City of Sugar Hill  
Planning Staff Report  
**Town Center Overlay District (TCO) Design Review 16-01022**

**DATE:** December 30, 2016  
**TO:** Mayor and Council, TCO Design Review Board  
**FROM:** Planning Director *KA*  
**SUBJECT:** 1090 Old Cumming Road – Doug Duffee – Sugar Hill Auto Collision

**ISSUE** The City of Sugar Hill has received an application from Doug Duffee requesting design review board approval for the roof top intake and exhaust required for the paint booths at the newly constructed building located within the Town Center Overlay District.

GARMAT 99830X, 27' 3000 SPRAY BOOTH  
with ELEVATIONS, ISOMETRIC VIEW  
and SPECIFICATIONS  
extD10 MECHANICAL POSITION

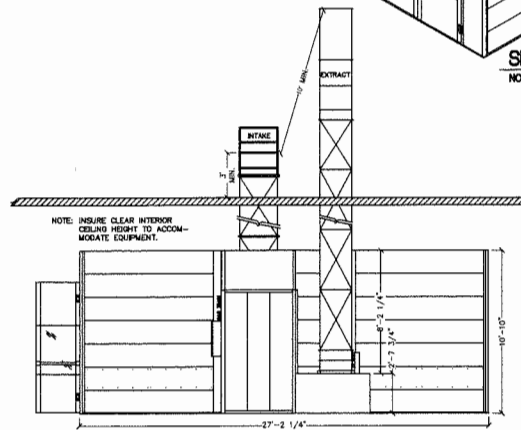
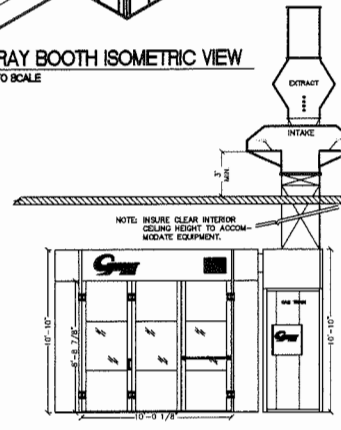
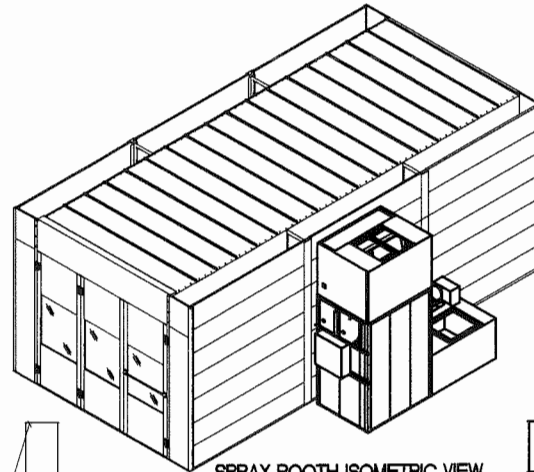
No elevation drawings have been submitted for review that show the intake and exhaust equipment relative to the building, but based on the provided shop drawings, the exhaust will protrude more than 10 feet above the roof line and will be located near the front entrance of the building. It appears that the project, as currently designed, does not comply with item iii above, as no screening has been shown.

The protrusion of the mechanical structure so much above the roof line results in an appearance that is incongruent with the overall character of the rest of the building. Therefore, it is recommended that screening be added to the building or that the mechanical equipment be otherwise rearranged to be less obtrusive.

***Denial. A physical screen painted black or a color matching the building shall be required.***
